**Department of Transportation
Olympia, Washington 98504**

**I-405
SPRINGBROOK CREEK WETLAND AND
HABITAT MITIGATION BANK
A State Project**

Addendum No. 5

The Plans and Specifications for this project are amended as follows:

SP6

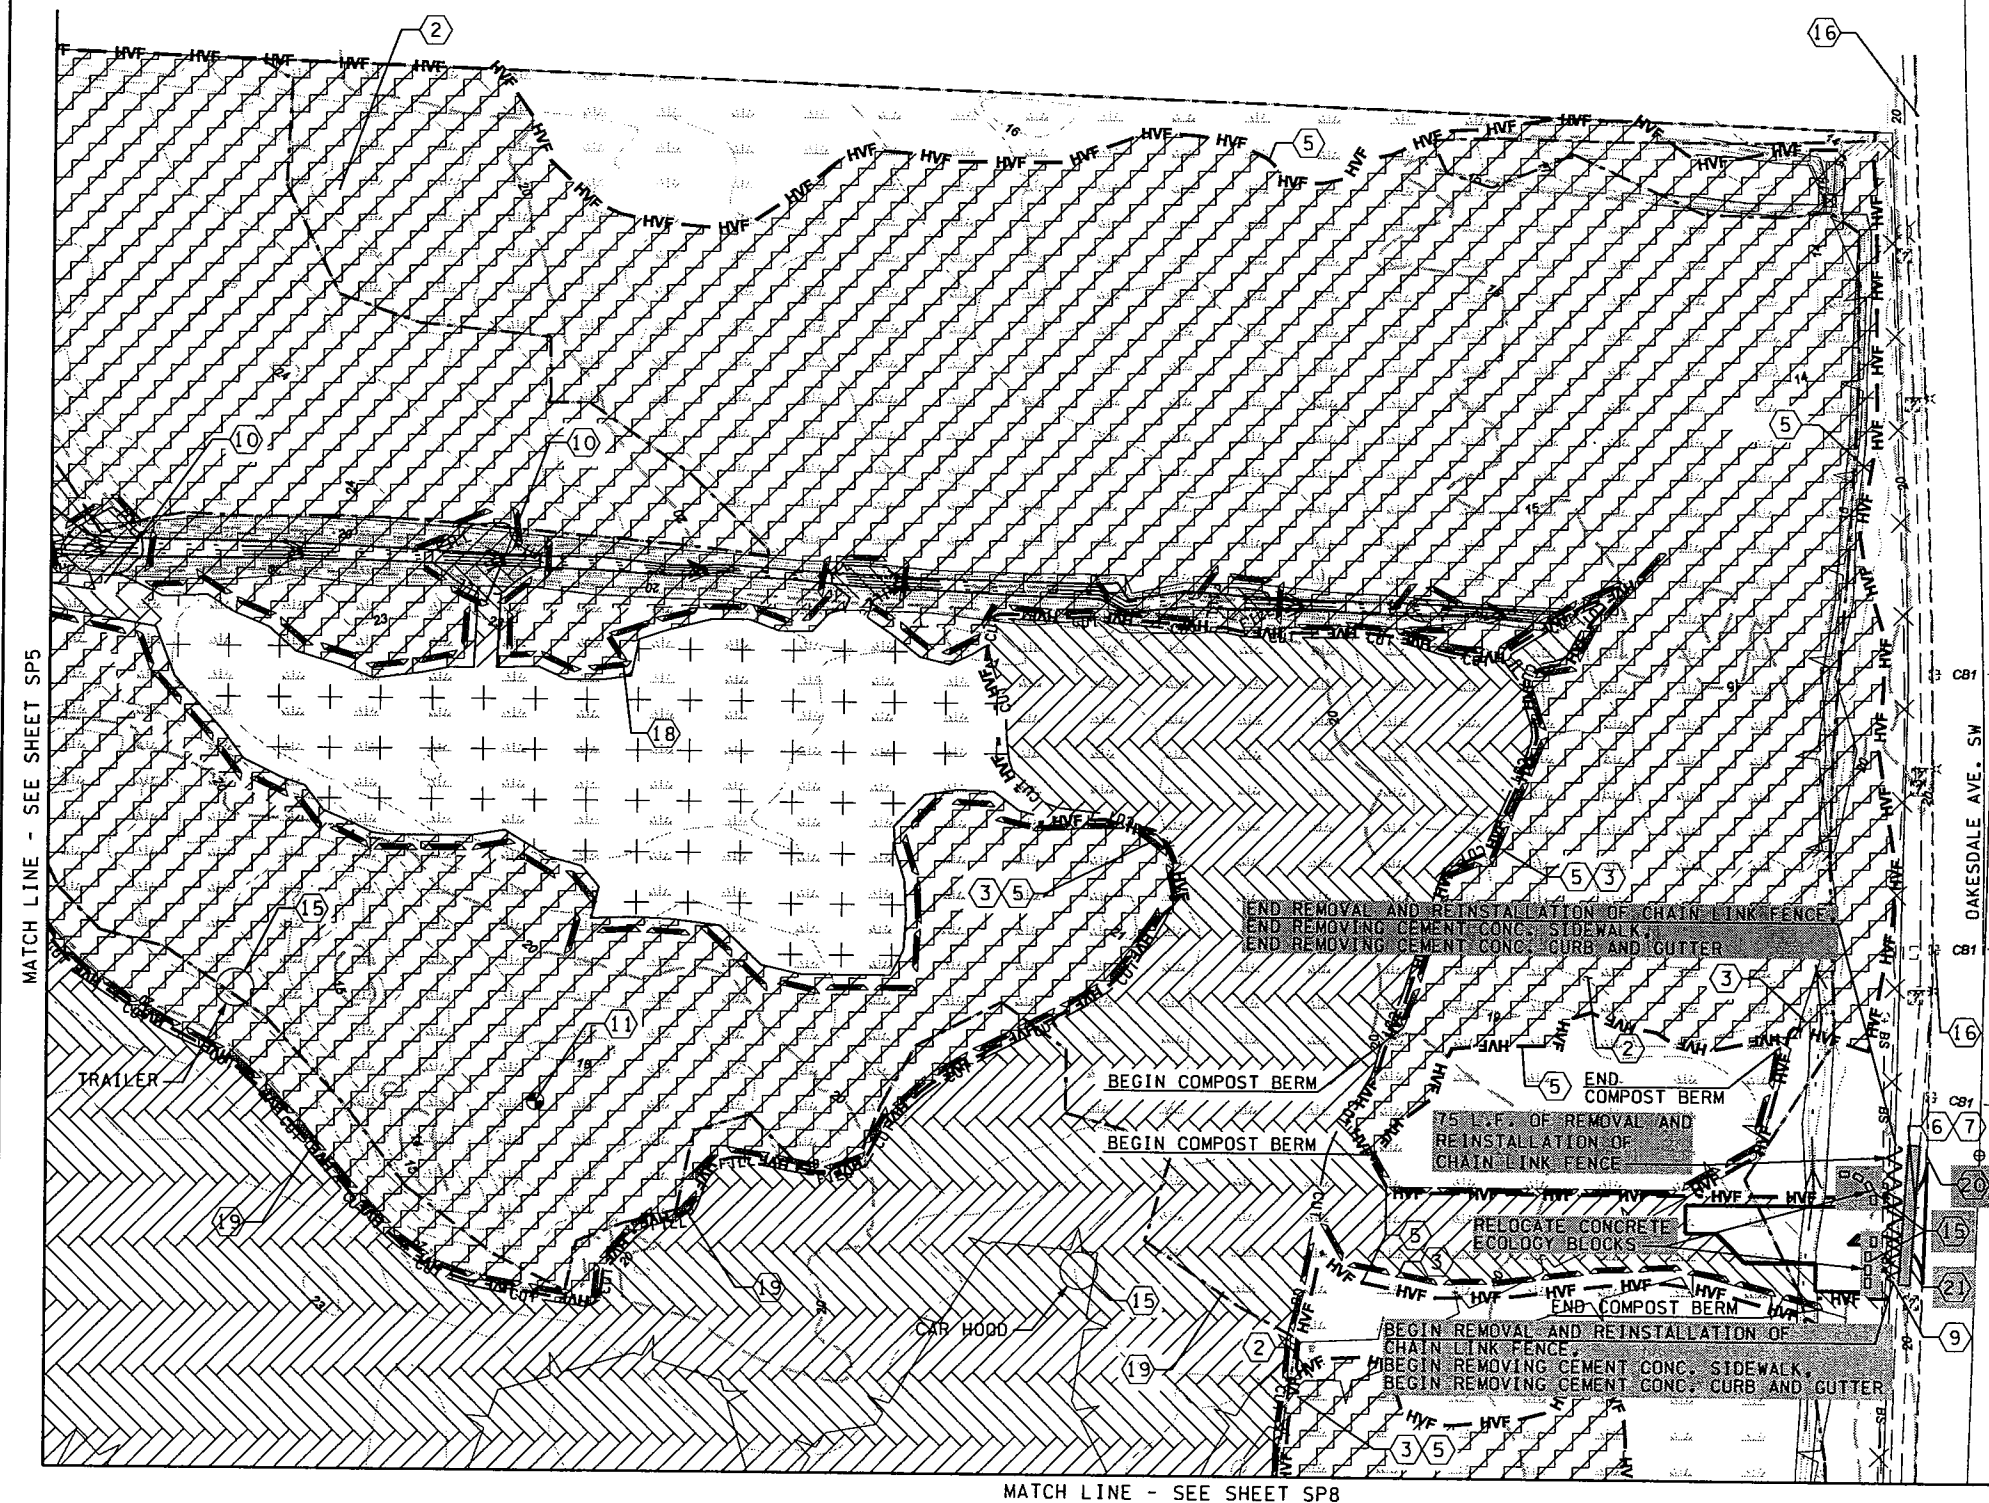
The Contractor shall move the Ecology Blocks on the east side of Unit C, as shown in the Plans, to a location east of the existing Unit C chain link fence and west of Oaksdale Avenue, as approved by the Engineer.

ADDED REMOVALS AND ECLOGY BLOCKS

SP11

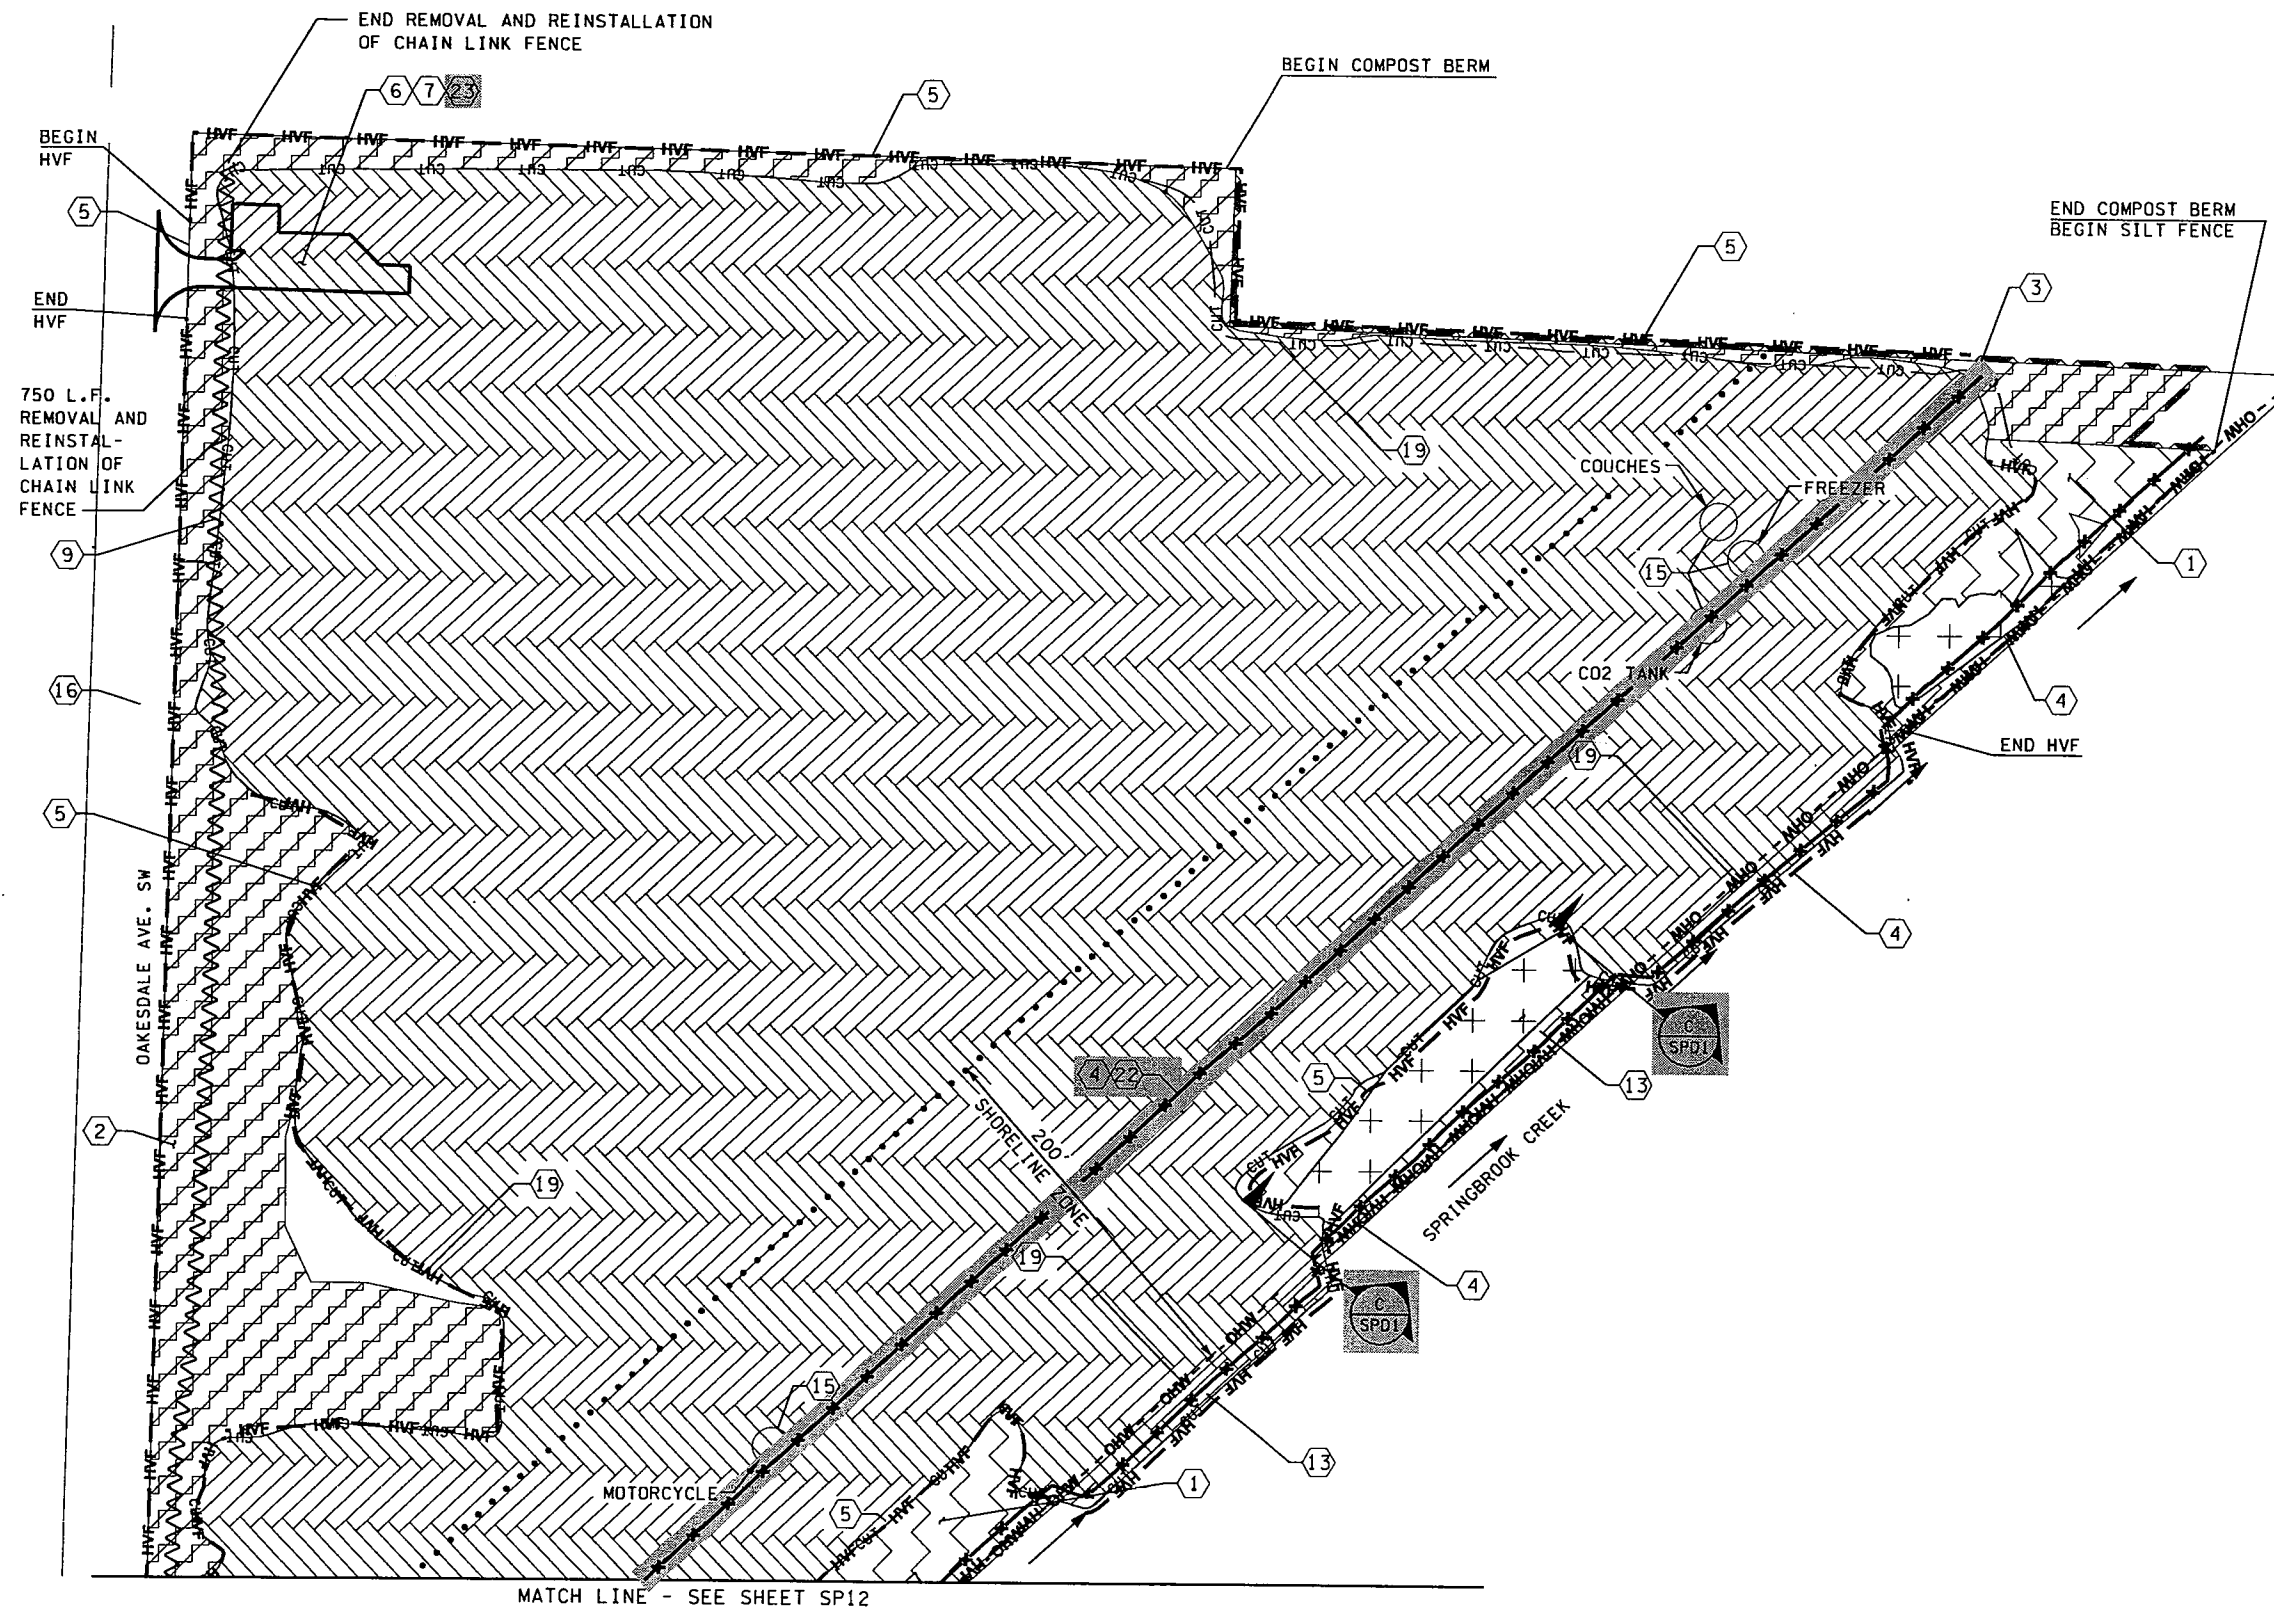
- ⑳ SILT FENCE FOR UNIT E SECOND ORDER OF WORK (BREACHING THE EXISTING BERM).
- ㉑ LOCATION OF CONSTRUCTION ENTRANCE MAY BE ADJUSTED WITH ENGINEERS APPROVAL, IF ALTERNATIVE LOCATION IS PROPOSED BY CONTRACTOR TO IMPROVE ACCESS FOR UNIT E SECOND ORDER OF WORK.

ADDED SECTION C AND SILT FENCE

SPD1

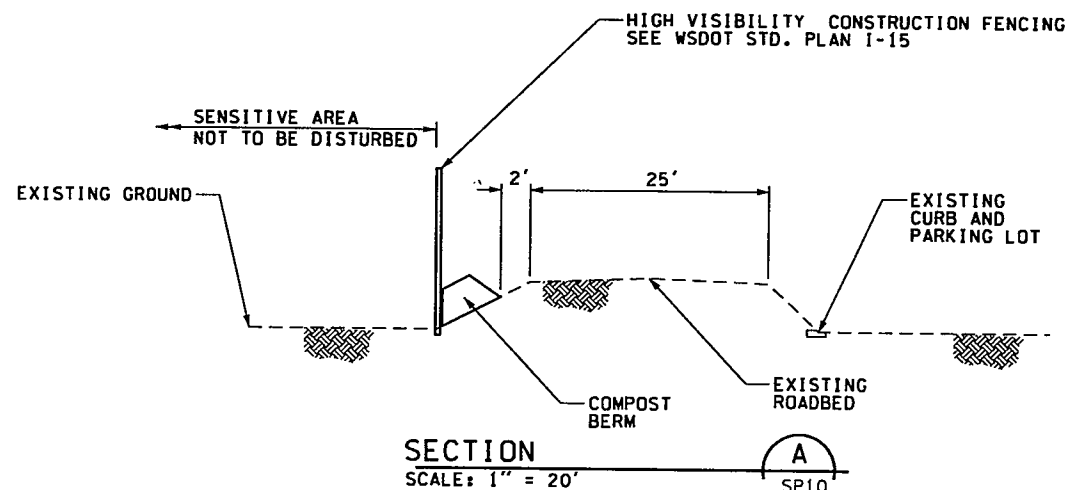
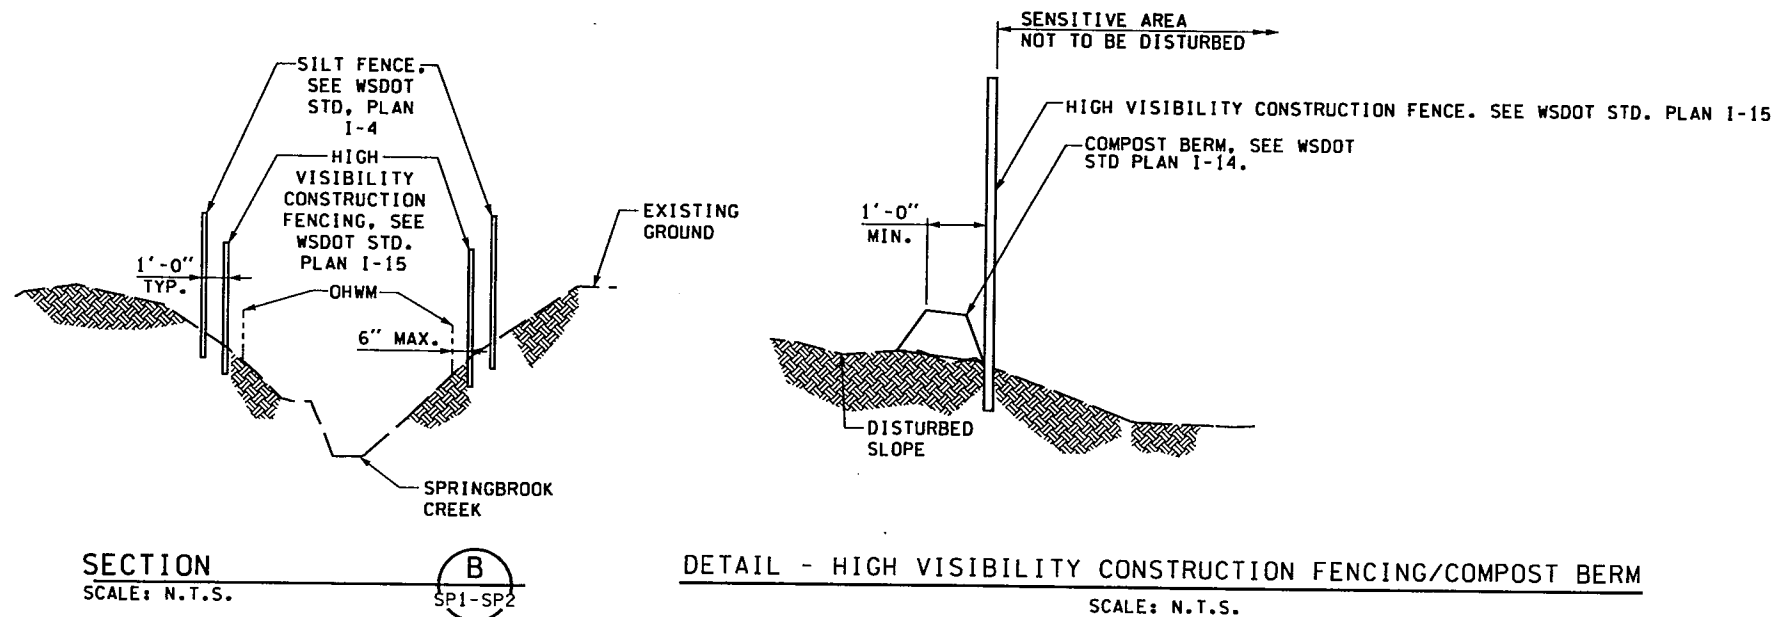
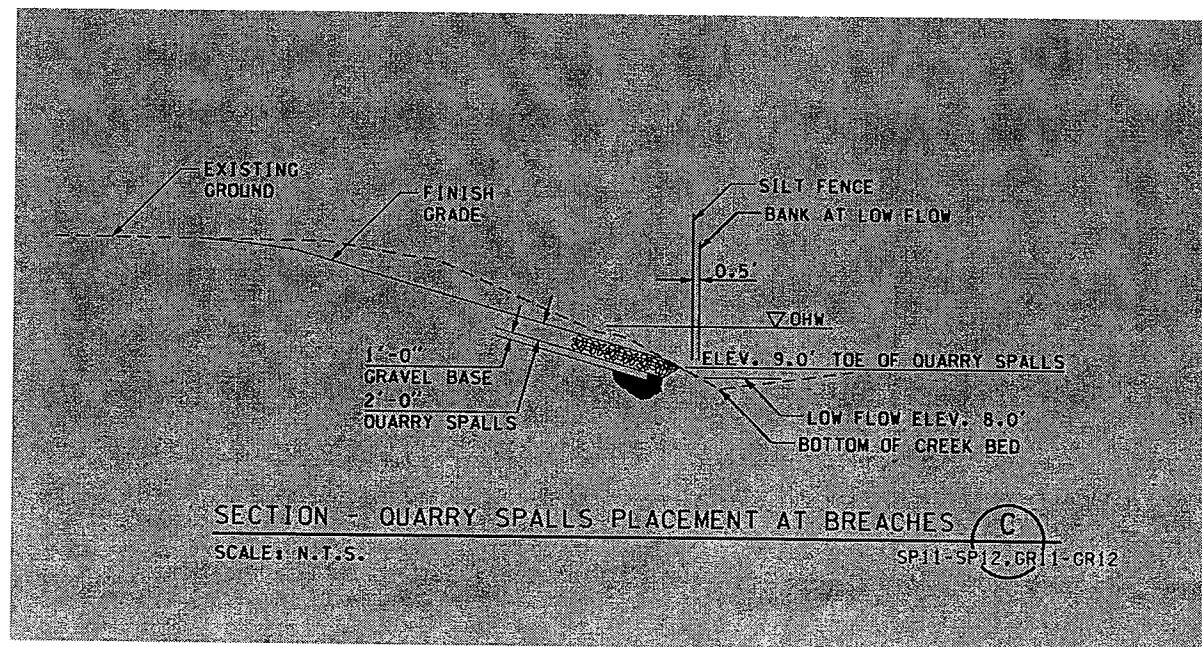
ADDED DETAIL - QUARRY SPALLS
